Docket Number:	00-AFC-01C
Project Title:	Contra Costa Power Plant Project Compliance
TN #:	203404
Document Title:	Petition for Staff Approval on Equipment Modification
Description:	N/A
Filer:	Angel B. Espiritu
Organization:	PG&E Gateway Generating Station
Submitter Role:	Applicant Representative
Submission Date:	12/5/2014 11:01:49 AM
Docketed Date:	12/5/2014

Subject: GEN-1: REQUEST FOR APPROVAL ON EQUIPMENT CHANGE
(Installation of Fixed Hydrogen Tube Bank)

**REQUEST FOR APPROVAL ON EQUIPMENT CHANGE
AT
GATEWAY GENERATING STATION (GGS)**

Proposed Bulk Hydrogen Storage Skid Installation Location Footprint

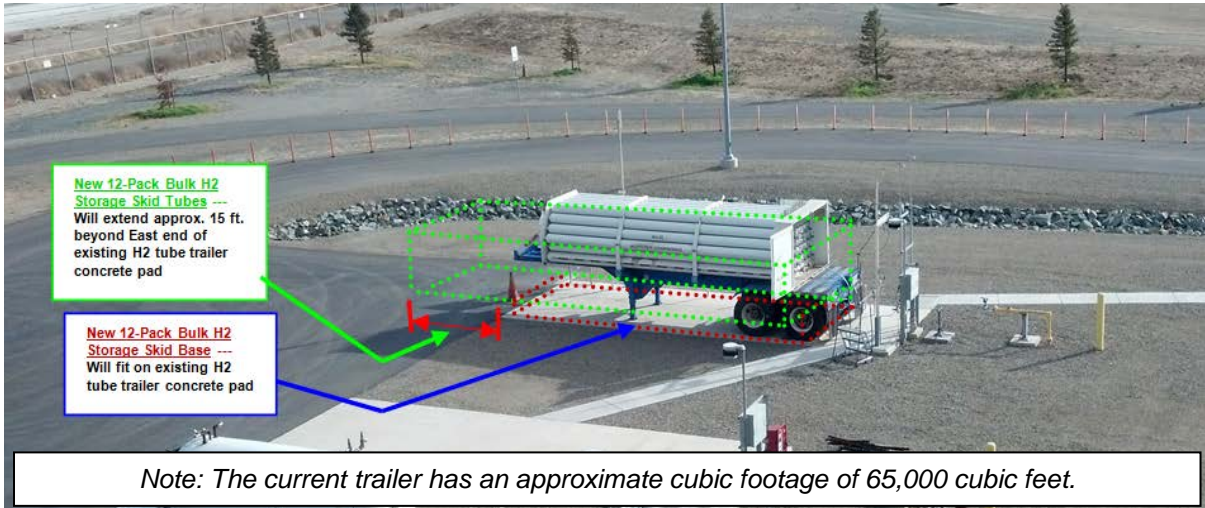
a. **Description of Modification:** This modification proposes to install a bulk hydrogen tube module (“12 pack”) which will be secured to a concrete pad in the same location where the mobile tube trailers are currently in use. The tube module is similar to a trailer; however it has no wheels and will be secured and protected by permanent traffic barriers. This module will be connected to the existing supply piping.

Layout of proposed tube bank installation in this location:

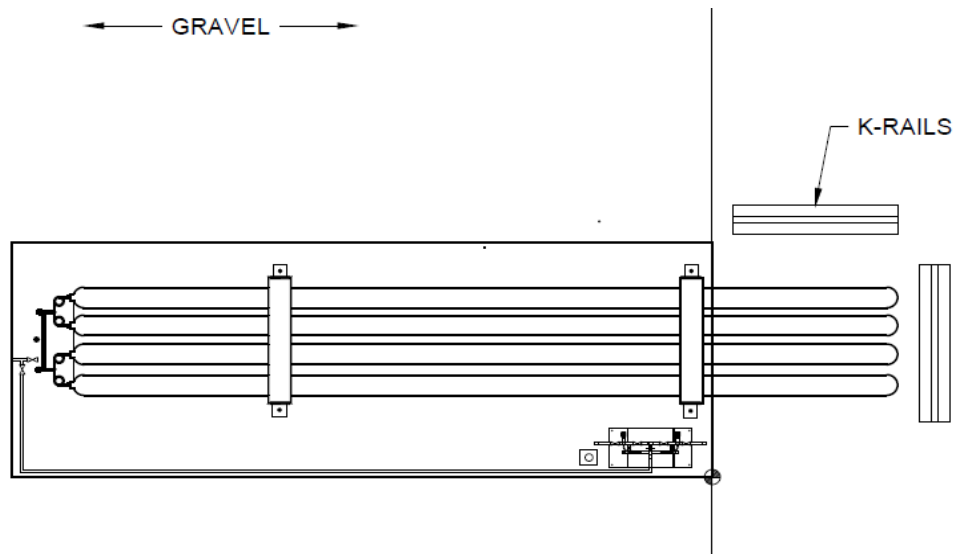
Note: This tube bank has an approximate cubic footage of 54,000 cubic feet.
